Haddam Neck Plant
Additional Information - Steam Generator Water Hammer

ADDITIONAL INFORMATION - STEAM GENERATOR WATER HAMMER

NRC REQUEST FOR ADDITIONAL INFORMATION ON STEAM
GENERATOR WATER HAMMER

C.V. REACTOR TRIP ON
5/4/78
#1 STEAM GENERATOR LEVEL
(NARROW RANGE)

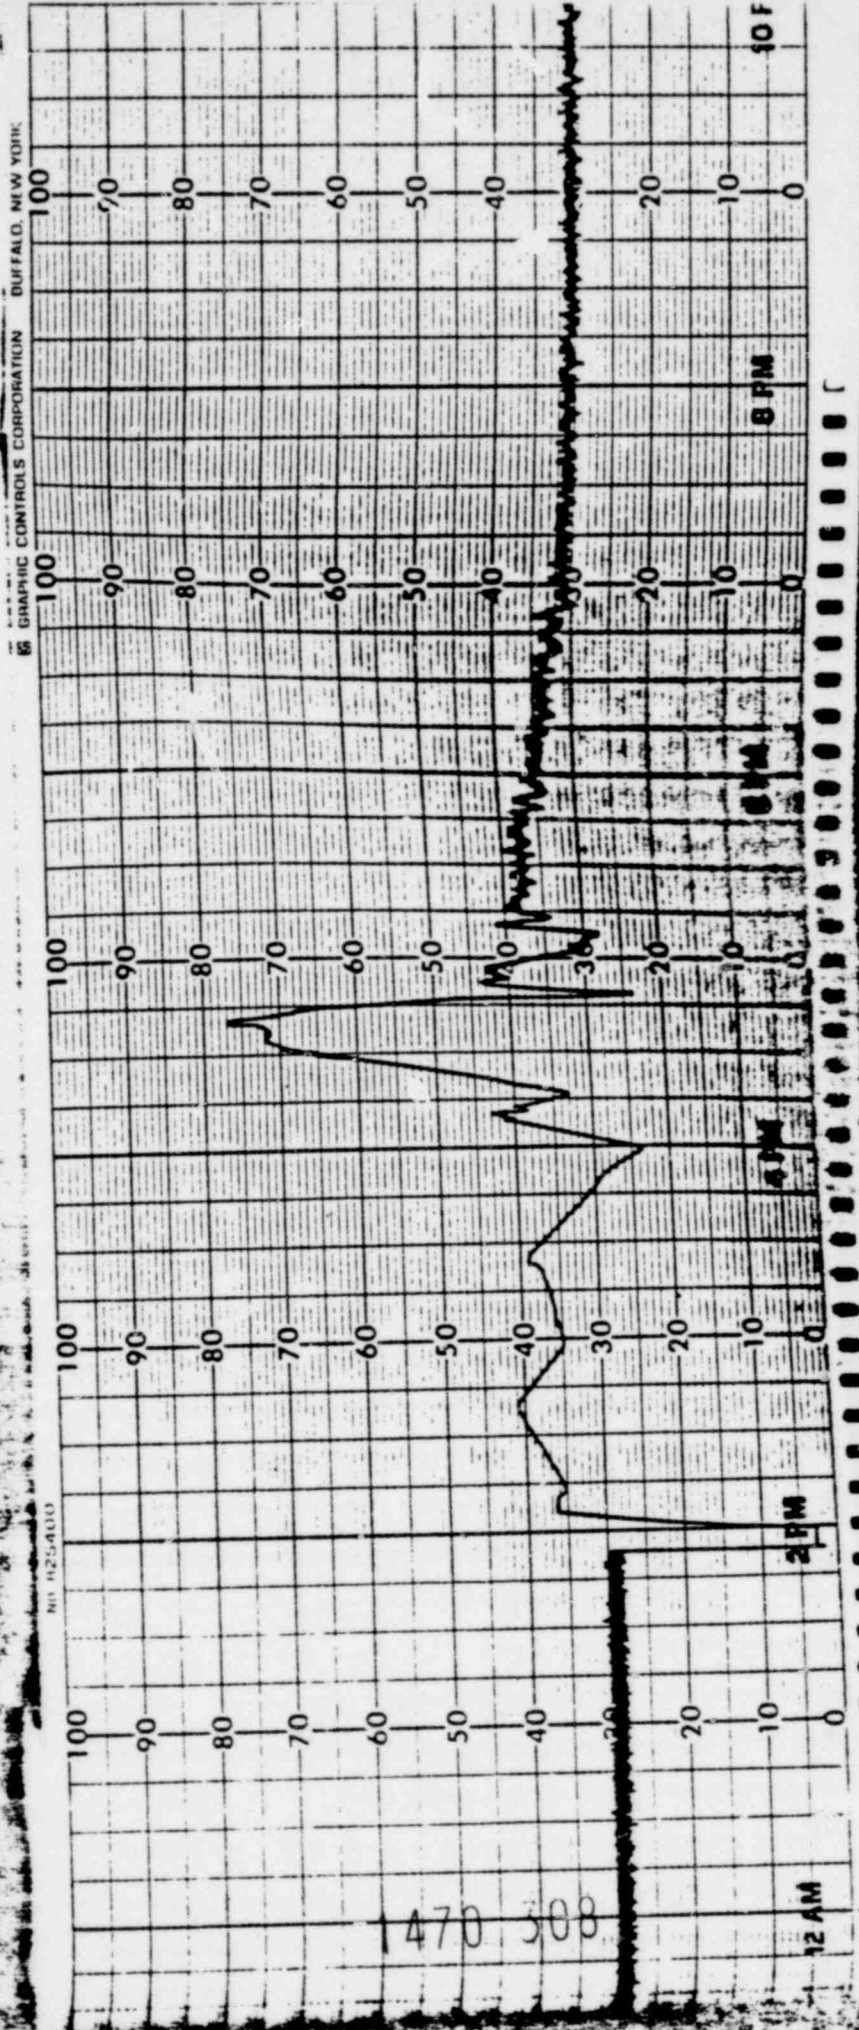
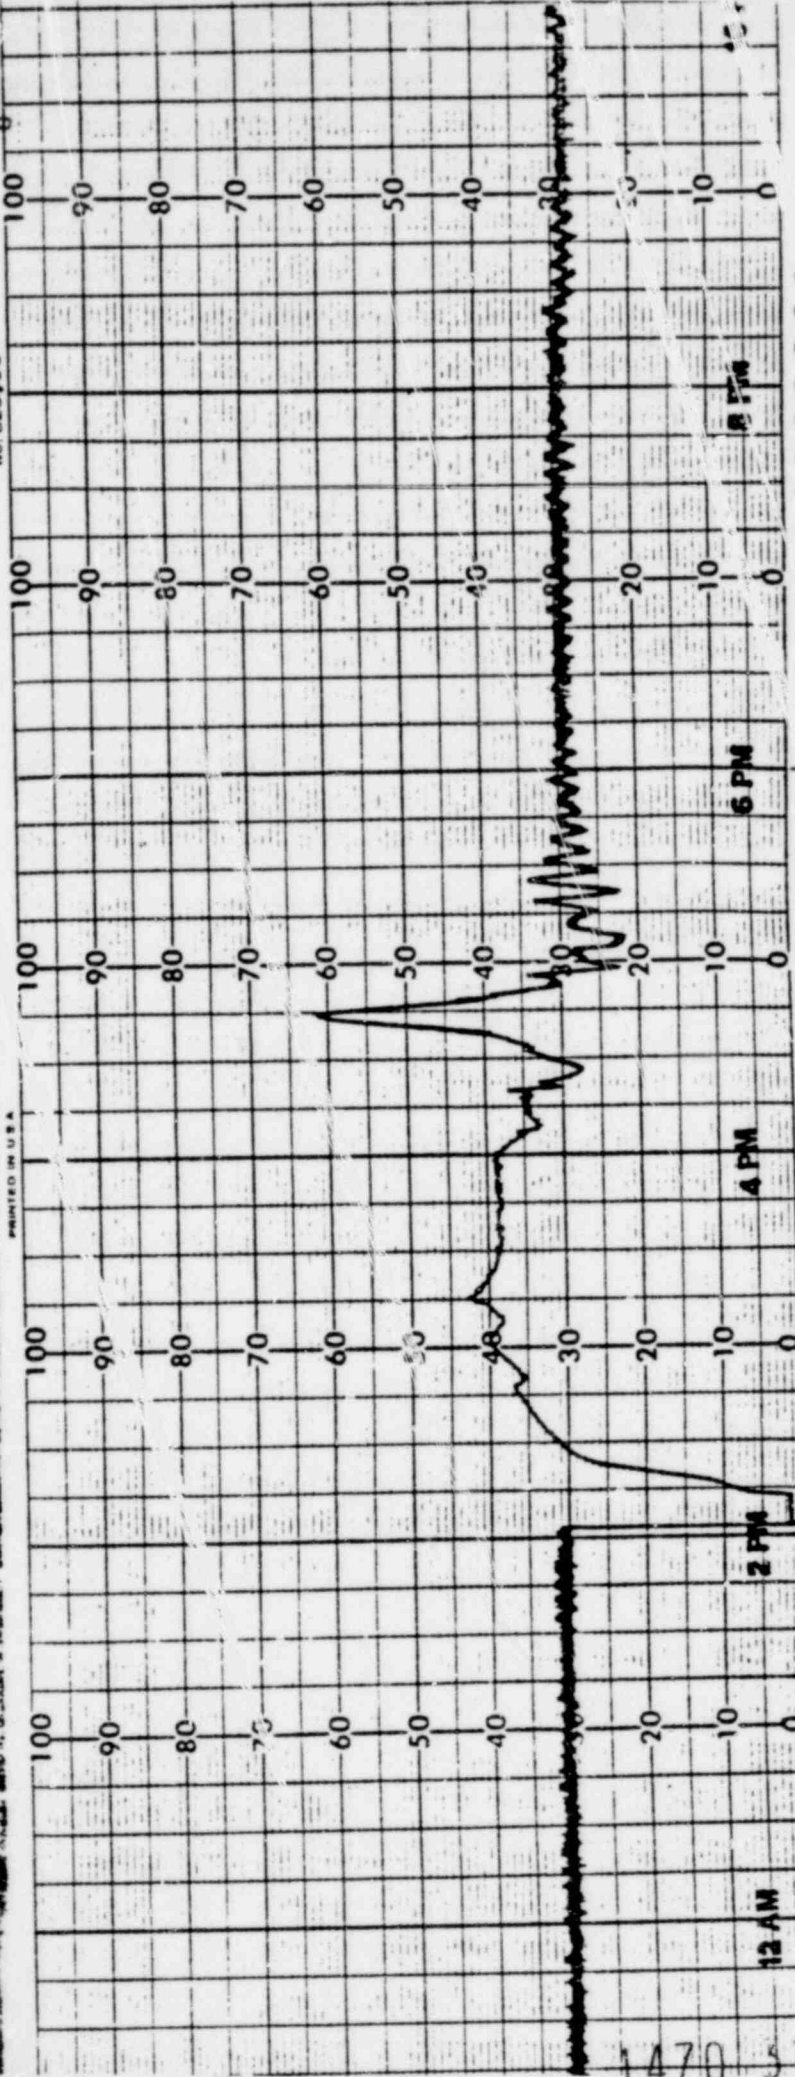
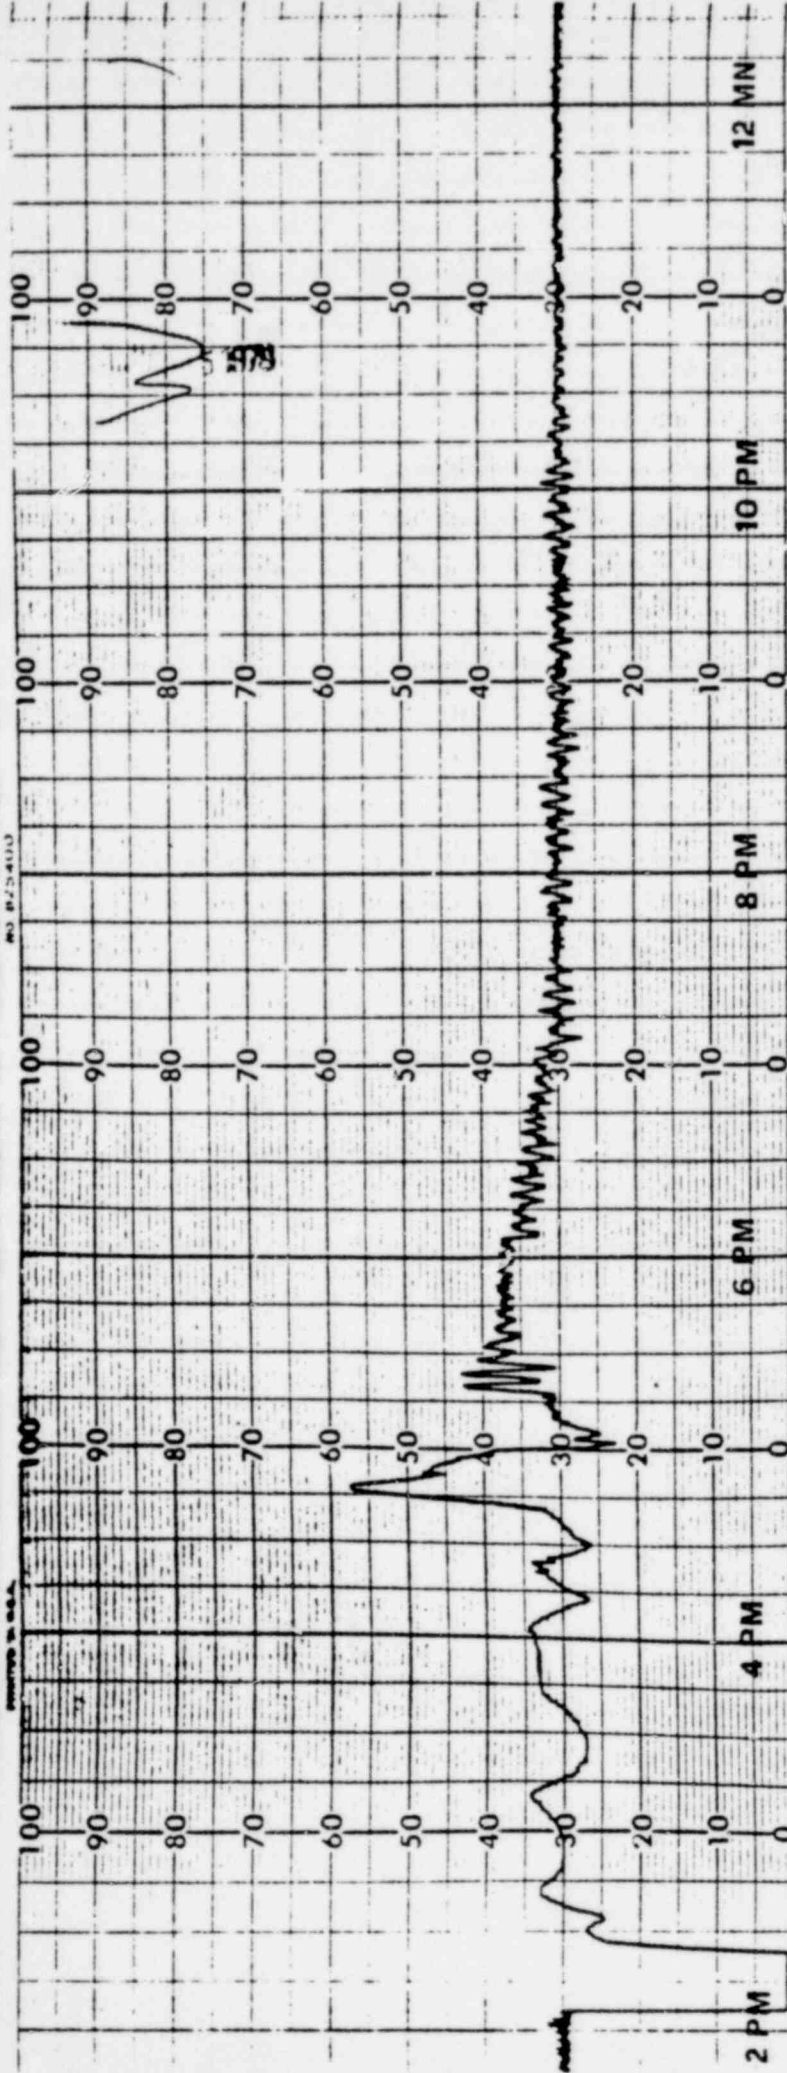
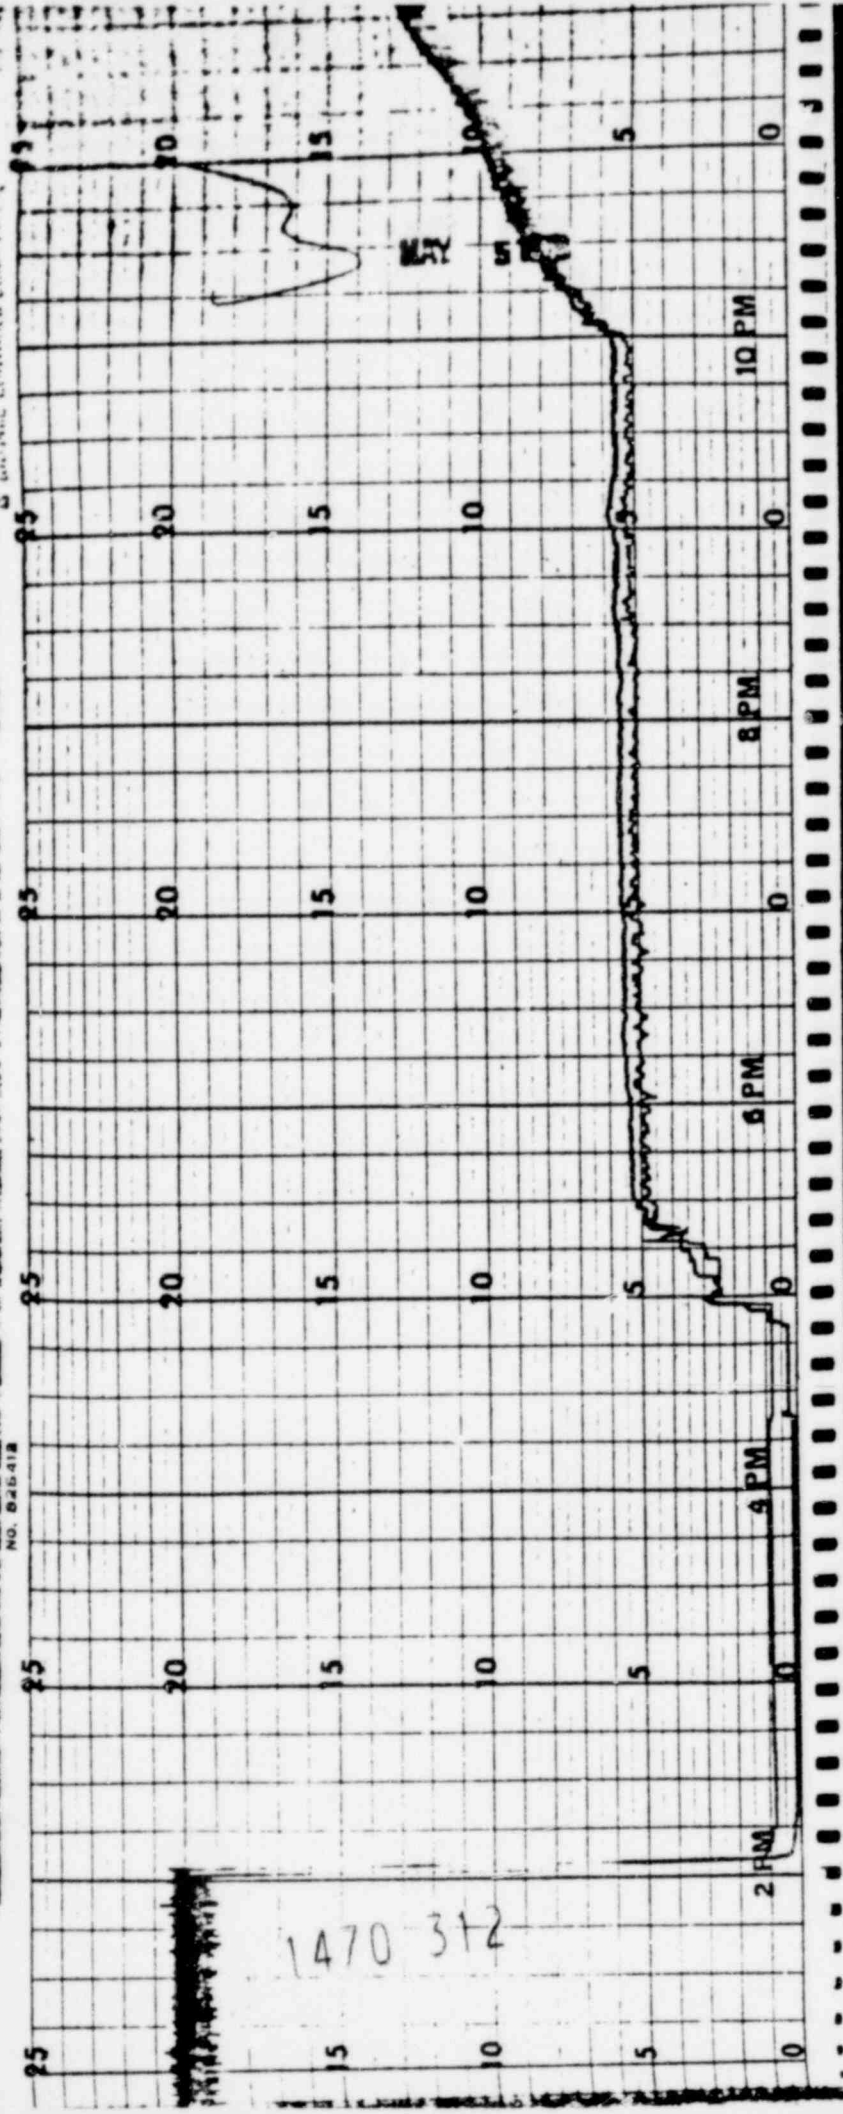
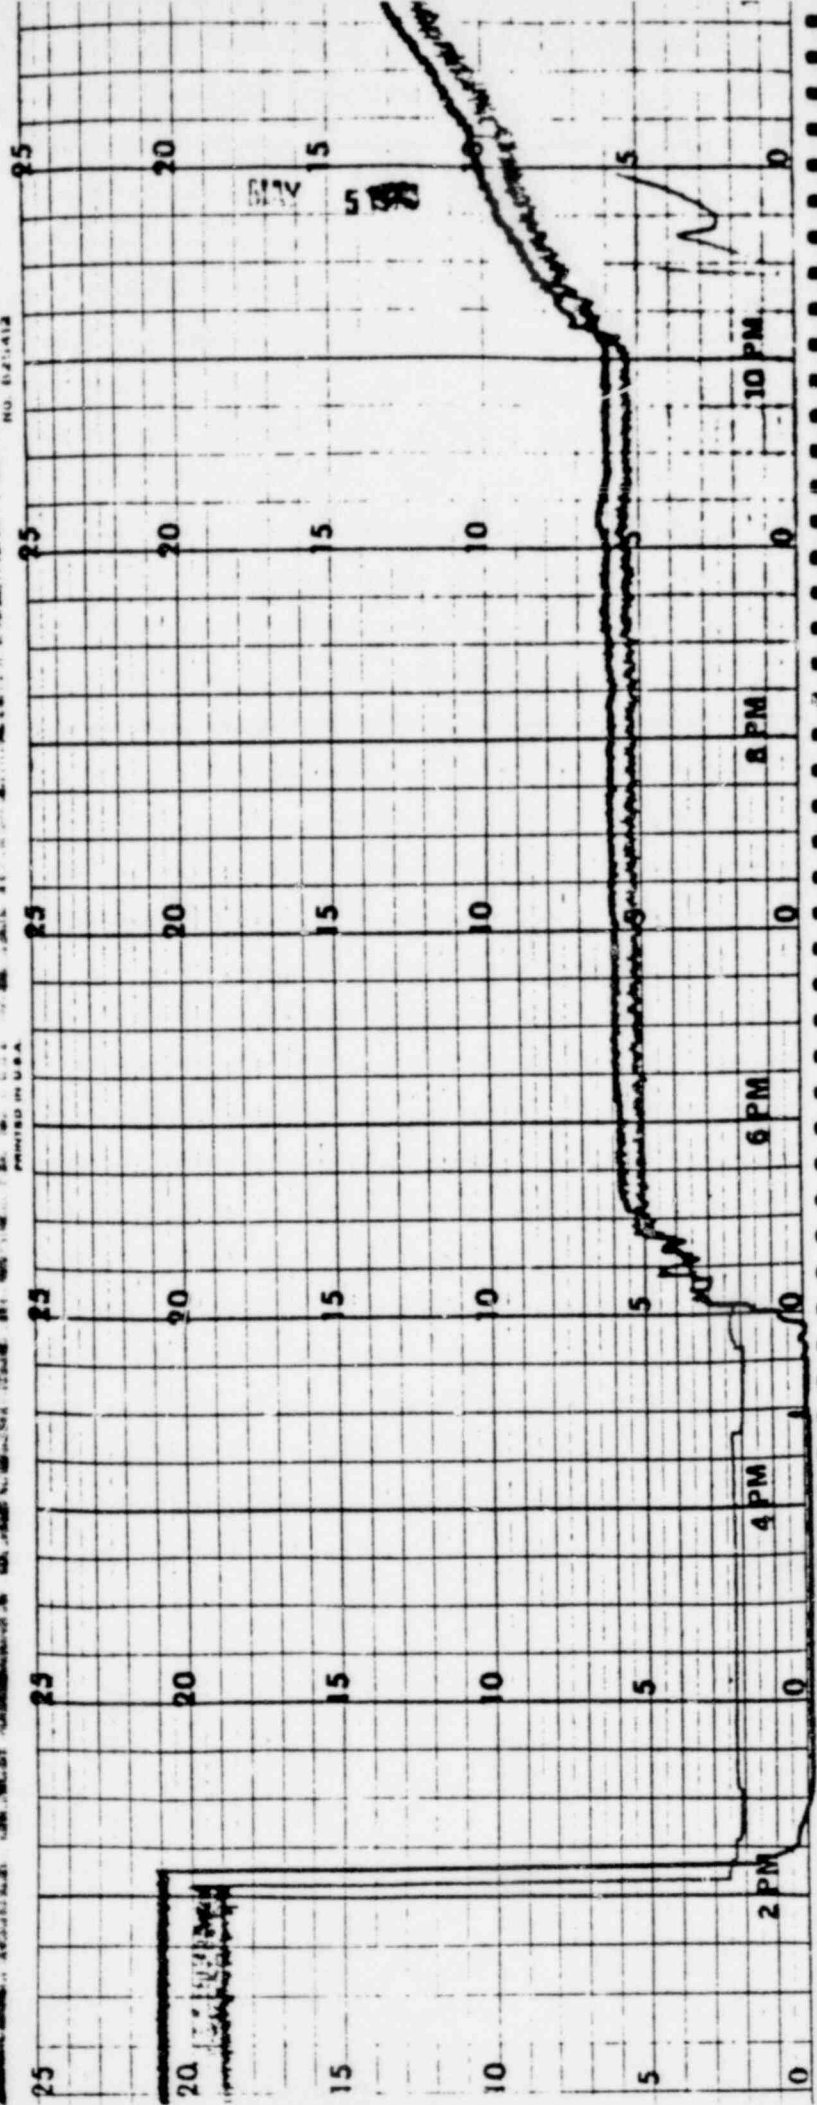
- 1.1 Describe the expected behavior of steam generator water level as a result of reactor trip from power levels greater than 30% of full power. Include actual plant measurements of steam generator level and other available data such as feedwater flow and auxiliary feedwater flow.

Actual plant measurements of a reactor trip which occurred from full power on May 5, 1978 are provided. This data represents the steam generator water level (narrow range 0-100%) and feedwater flow/steam flow (lbs/hr) for each steam generator. Feedwater bypass flow and

auxiliary feedwater flow are not available since they are not recorded. The data which is presented is representative of all reactor trips.
